A G E N D A

Architectural Review Board

February 23, 2016

965 Cloverdale Road

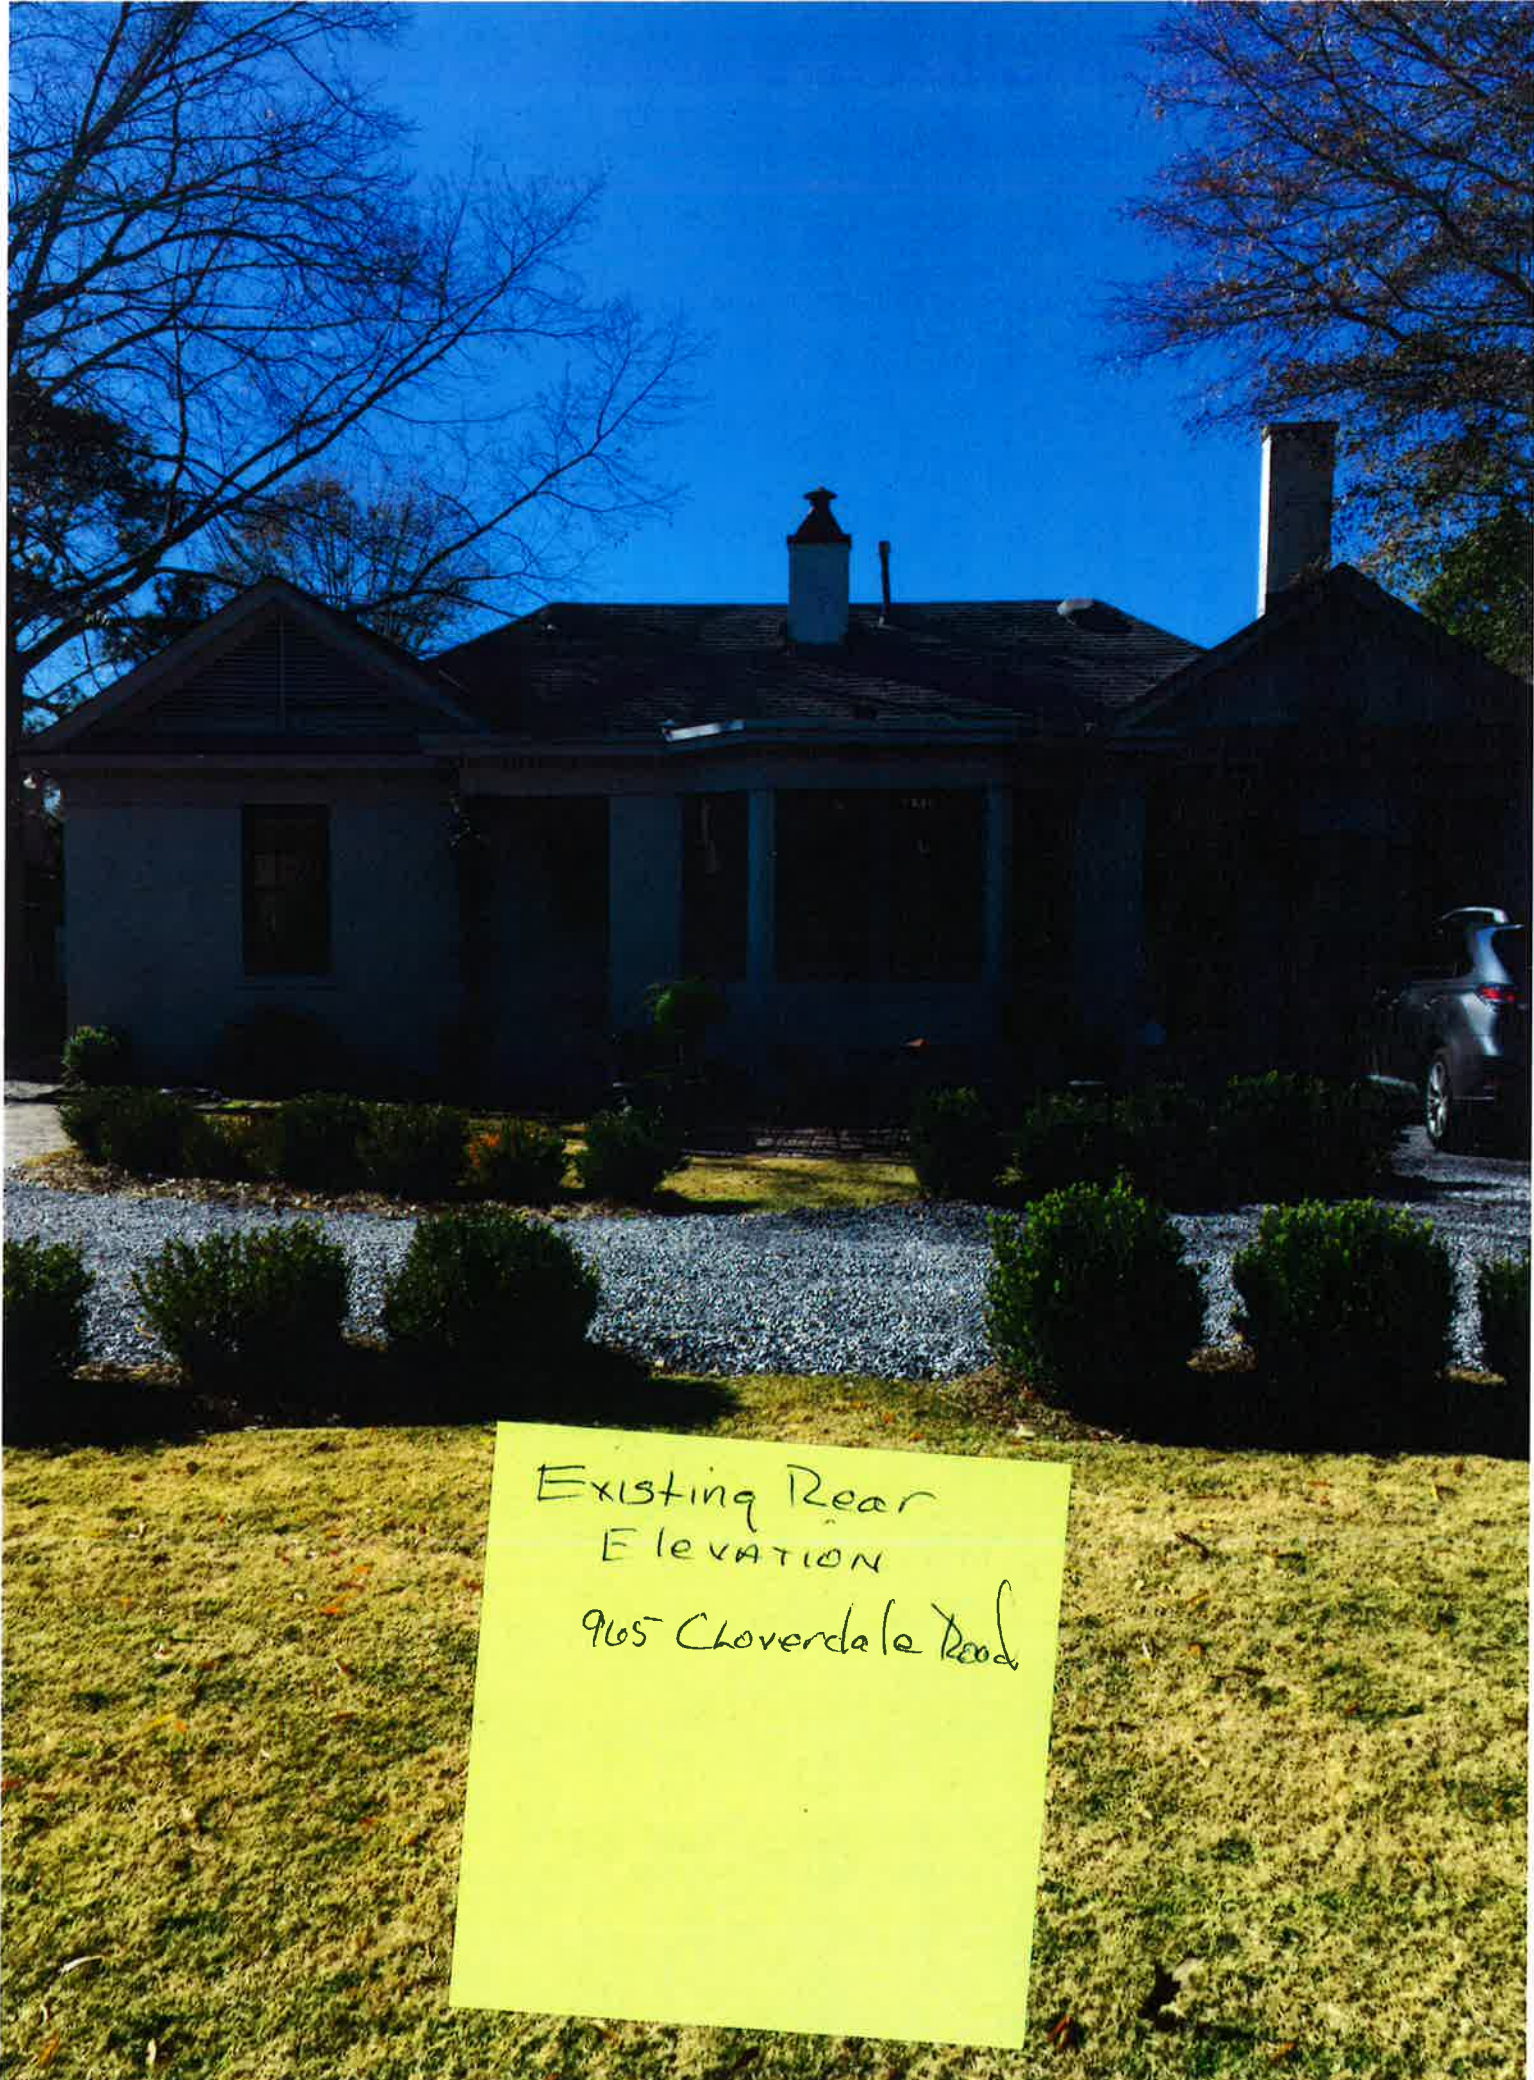
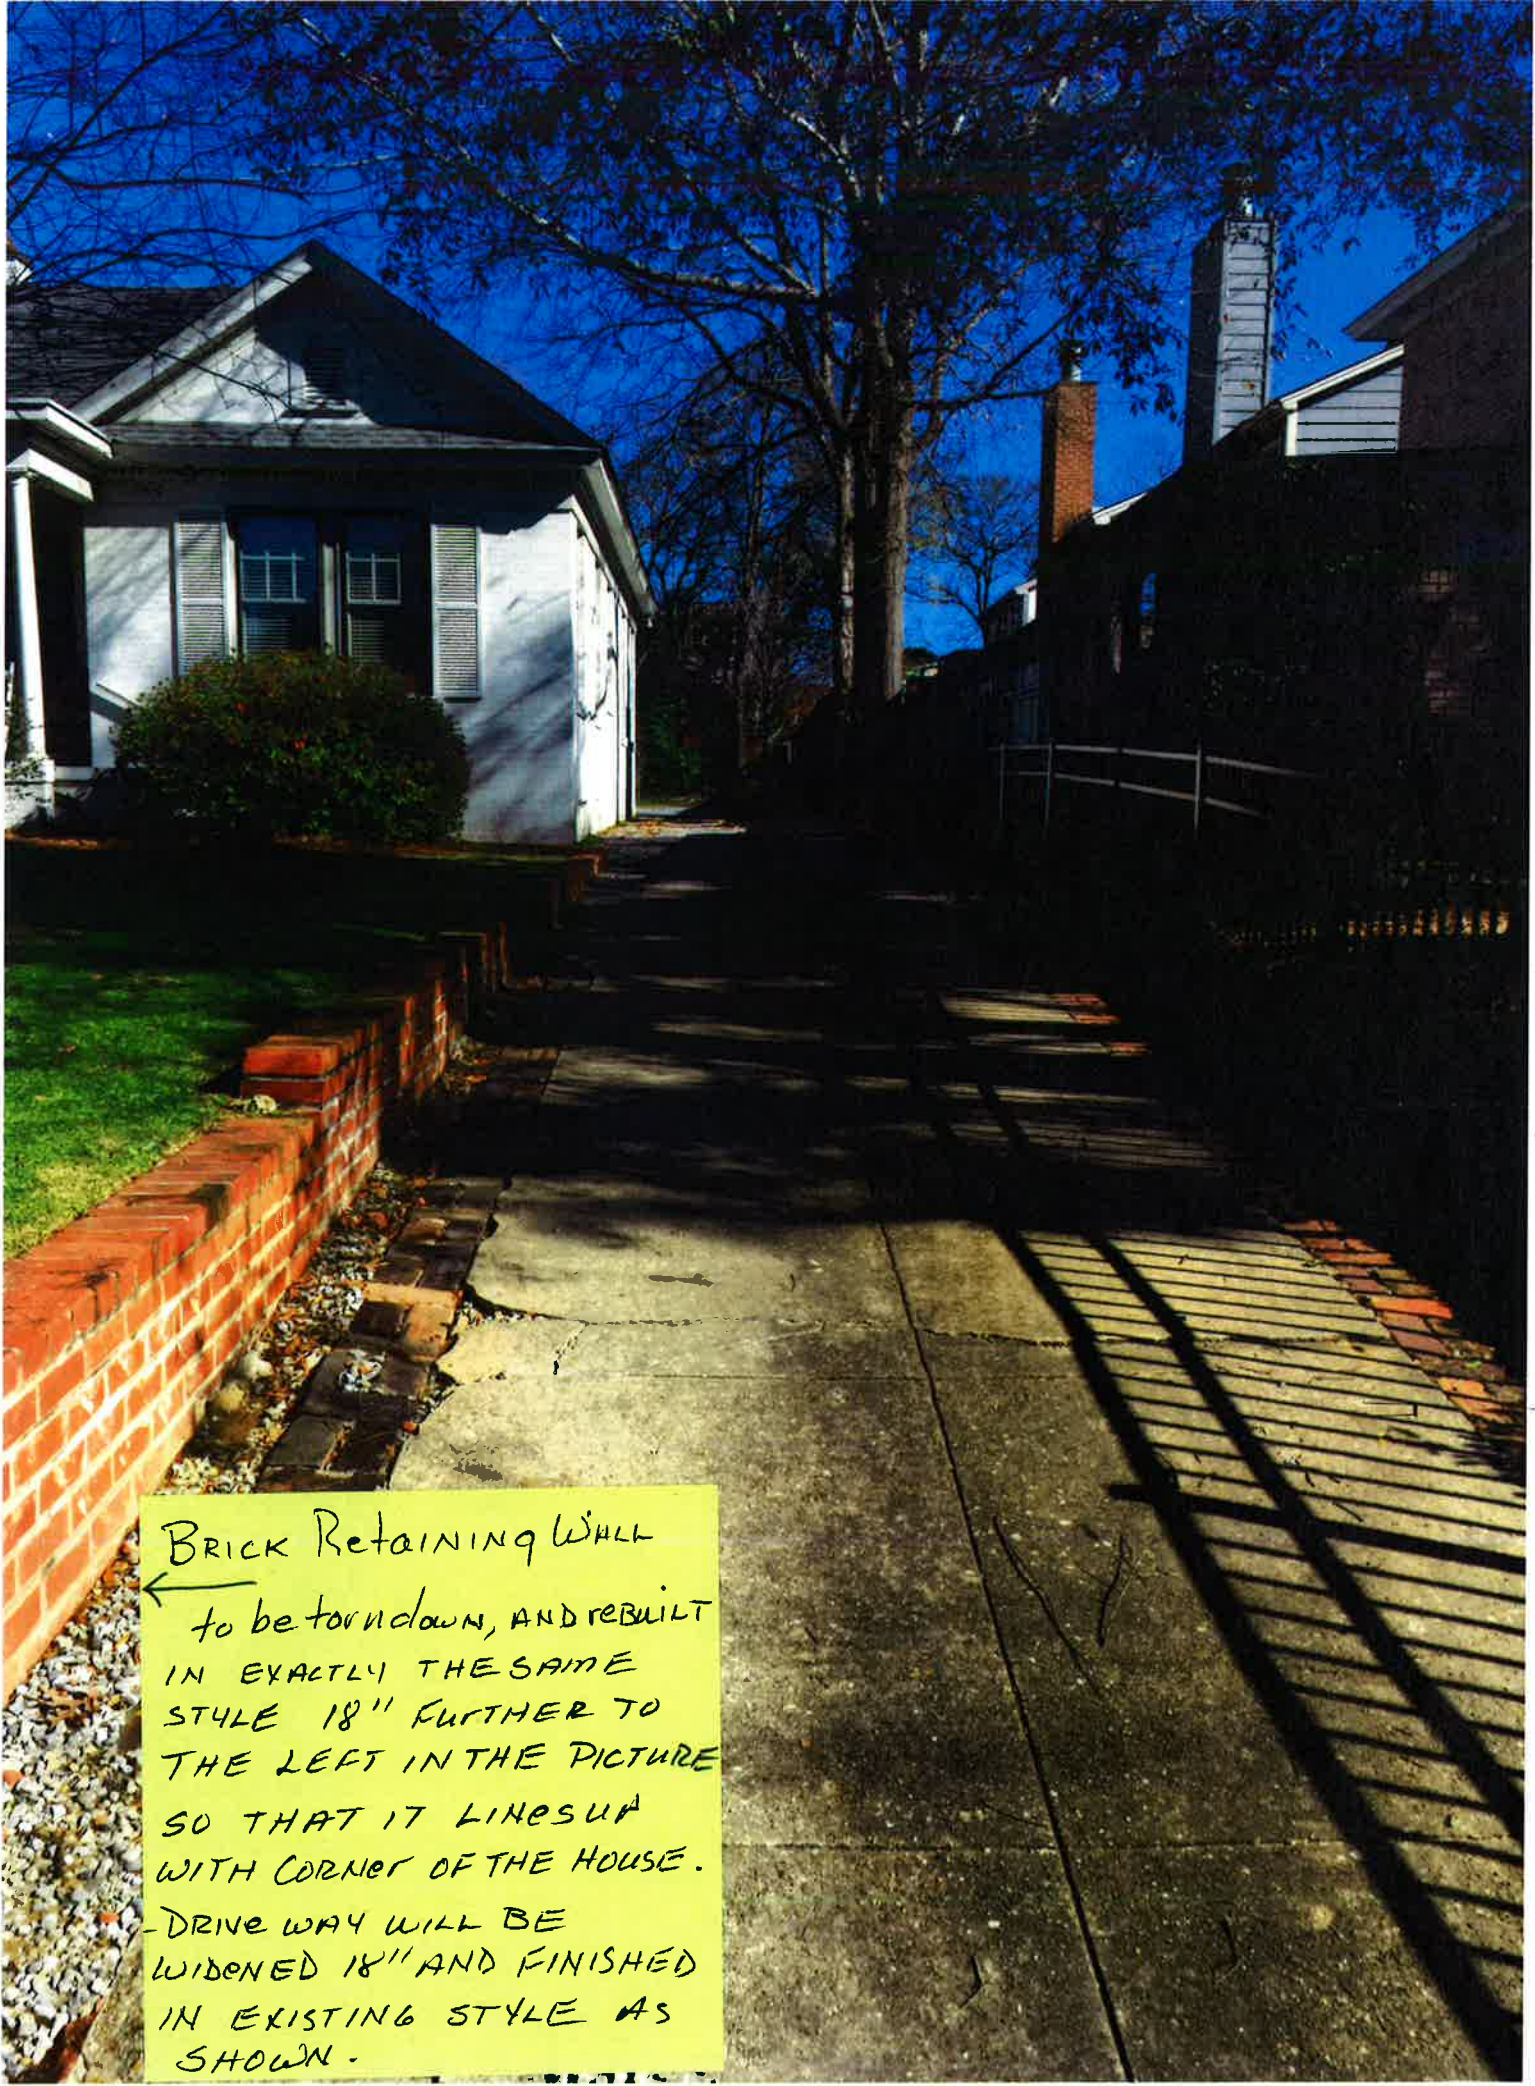
- The Board has previously approved the use of metal roofs on porches and low slopes to help address drainage issues.
- Plans are inserted into the agenda packet separately on 11x17 paper
